TRO10032 LOWER THAMES CROSSING

SUBMISSION after ISH1 (Issue Specific Hearing 1, 21st and 23rd June 2023) For Deadline 1 (18th July 2023)

SHORNE PARISH COUNCIL (IP ref 20035603)

RESPONSE TO THE NATIONAL HIGHWAYS "MINOR REFINEMENTS CONSULTATION" held May-June 2023

Main works compound south of A226 as shown in APP-051, Oct 2022:

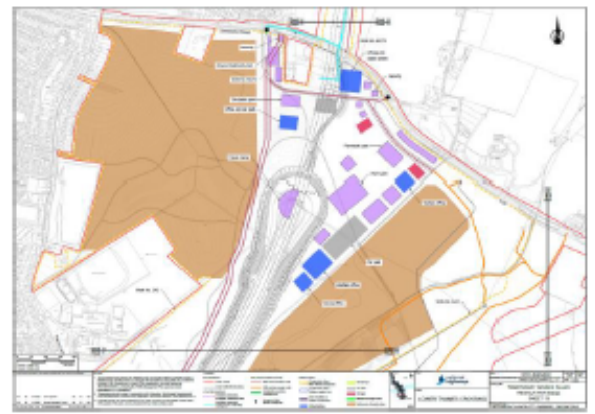
- Further change to the main southern works compounds is noted, with a great increase in buildings/structures, up to 25m high so resulting in significant local visual impact including near Chalk church. The suggestion that there is no significant change, as the crane is still the tallest structure, is rejected.

- Local residents have expressed concern that the presently discussed "possible" change was, despite reassurances, actually already planned for some time to be happening.
- The Parish Council considers that NH need to update/revise a considerable number and range of DCO documents in order to take account of this proposed or even just possible change to the previously informed and reiterated twin N-S tunnel boring scenario.
